## To Our Valued Customers,

This note affects a specific revision of the debug adapter that is shipped with the iMX Developer's Kit (several different versions exists of these kits).

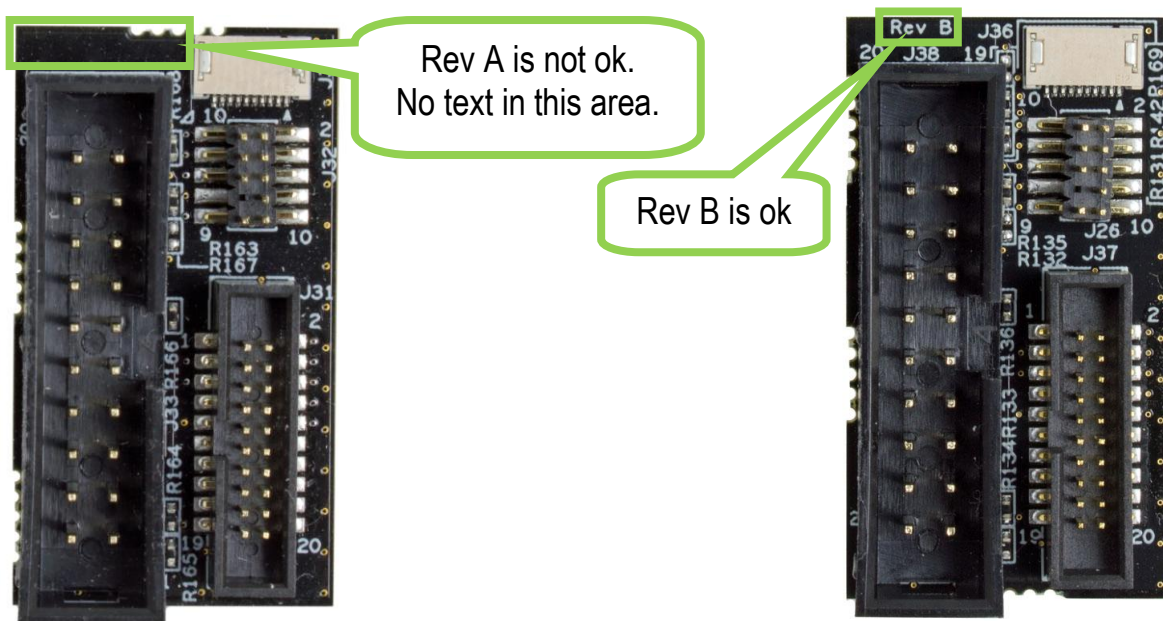
The affected revision (rev A) of the debug adapter is identified by the lack of text in the marked area, see picture below.

The TRST signal is not correctly connected on Debug Adapters, rev A. It permanently grounds the TRST input to the iMX application processor.

Note that this may, or may not, be a problem since not all debug adapters use the TRST signal.

If you have a Debug Adapter rev A and experience problems with JTAG connection, contact Embedded Artists and request a replacement Debug Adapter (rev B). When contacting Embedded Artists please also state which iMX Developer's Kit you have and revision of COM Carrier Board (rev A, B or C).
